RESPONSE TO EIS

Development	State Significant Development - UOW Seniors Living Development - Request to provide advice on Environmental Impact Statement (EIS)
Location	Lot 100 DP 1320102 Lot 101 DP 1320102 Lot 13 DP 1172135 Lot 7 DP 1172135 Lot 9 DP 1172135 Lot 3 DP 1172135 Lot 10 DP 1172135 Lot 8 DP 1172135 Lot 11 DP 1172135 Innovation Campus 3-4 Innovation Way, 1-7 Squires Way, 6 Puckey Avenue NORTH WOLLONGONG NSW 2500

Figure 2 – Impact on view corridor

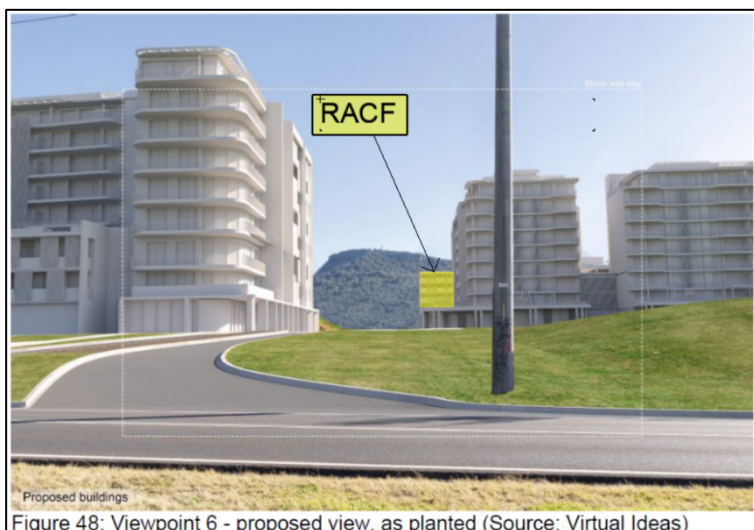
54. However, there will be a nominal impact upon view to Mt Kiera from Squires Way when entering the site from the east, as depicted in the image below:-

Figure 5 - Extract from Revised Urban Design Guidelines, issue U 28th May, highlighting changes to ILU2

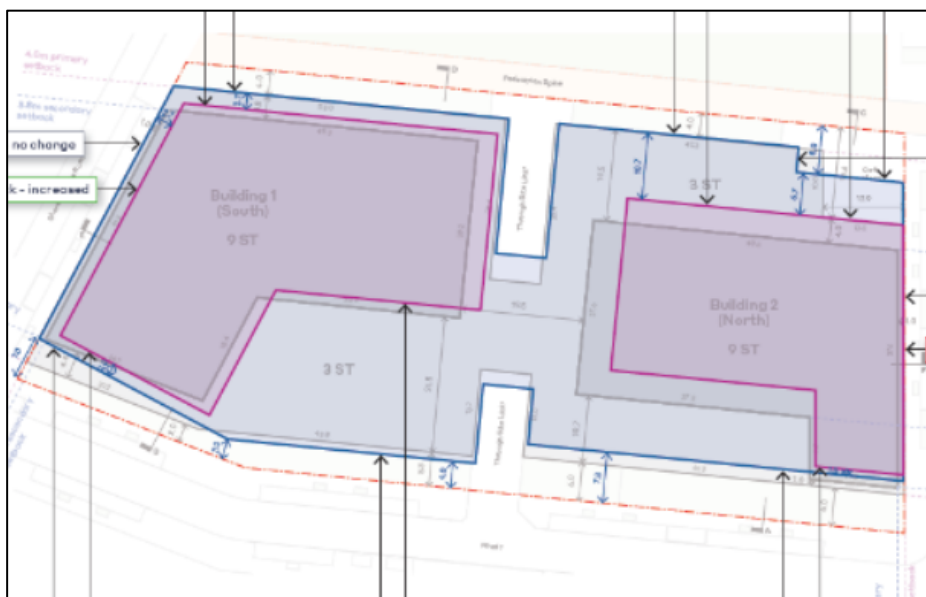
84. The proposed changes to the envelope of ILU2 have been clearly documented in the applicant's Revised Urban Design Guidelines, issue U dated 28 May 2026.
85. The footprint and number of storeys of the building remains largely consistent with the current approval. The most notable minor changes are:
 - The repositioning of the gap between building 1 and 2, this appears to have no negative impact upon the proposal's contextual response (views / solar).
 - The reduced upper-level setback to High Street (north), appears to be contributing to a more compressed entry point to the wellness precinct. This provides a contrast to the street scale within the precinct, that steps down to a lower scale that is predominantly single storey with towers above setback. This is a reasonable strategy.

Figure 8 - pedestrian spine comparison – DCP D14 masterplan comparison with proposed site plan

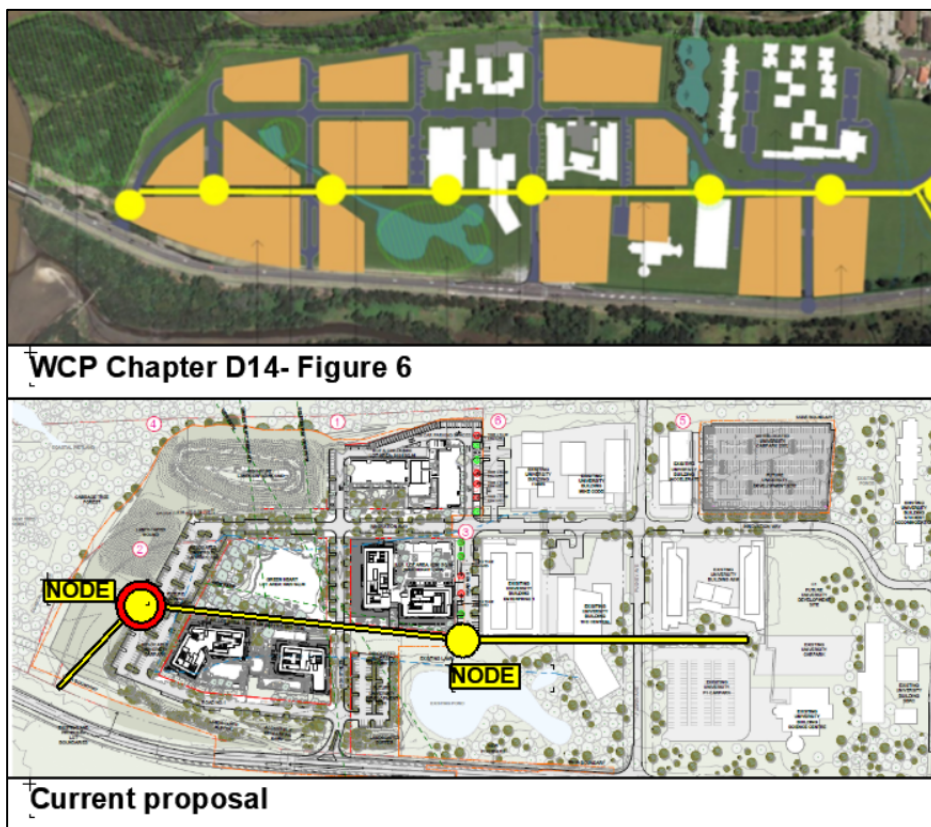
97. The removal of building forms from the southern edge of the site may also be developed to contribute to improved outlook and stronger connection with the site's natural environment, pending detail resolution to the landscape quality of the carpark. Consideration must also be given to how the changed condition of the southern perimeter of the site can contribute to a cohesive pedestrian route through the site, that connects back to the broader street network. The original DCP precinct plan provided a simple linear pedestrian route through the site that connected to Squires Way and Stuart Park beyond. The current proposal creates a pedestrian route that changes direction to accommodate buildings. This strategy is dependent upon creating visible nodes that draw pedestrians to an area before changing the direction of the path. One such node will be at the southern end of the site adjacent to the carpark. Consideration should be given as to how a visually prominent node is developed in this location.
